County of Hawai'i

PLANNING DEPARTMENT

Subject: Ohana Dwelling Unit Permit Application (OHD-09-000128)
Applicant(s): Don B. and Relda Nunes
Land Owner(s): Don B. and Relda Nunes
Proposal: Construct An Attached Ohana Dwelling Unit
Tax Map Key: (3) 2-5-007:023

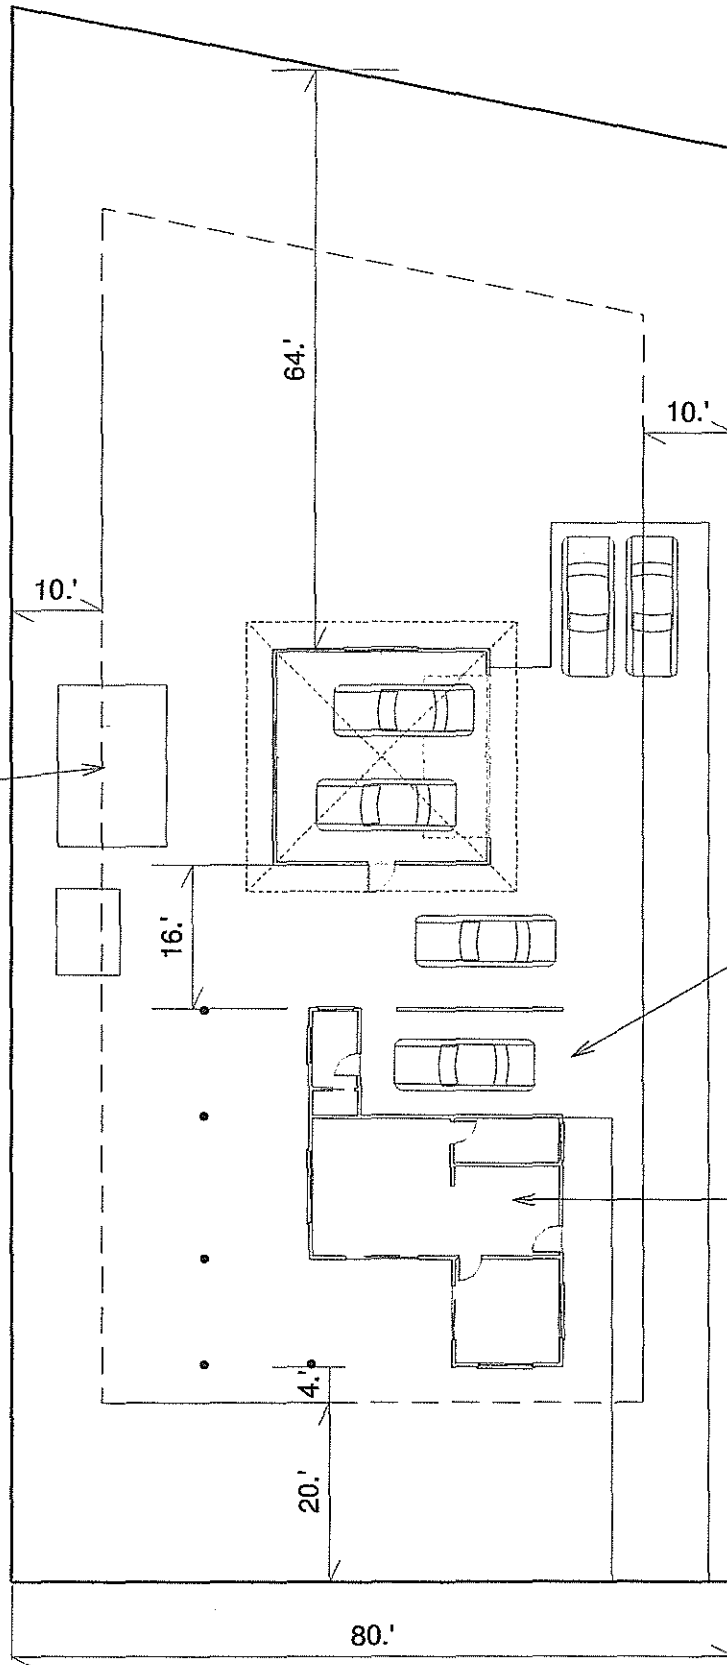
“Original building permit approved by the Health Department was for a 3 bedroom dwelling. Since the Ohana is for 1 bedroom, there will be 4 bedrooms on the septic system which was designed for 3 bedrooms.

3 Bedroom
Septic system

One parking stall
under house

one bedroom Ohana will
be on ground level, under
house
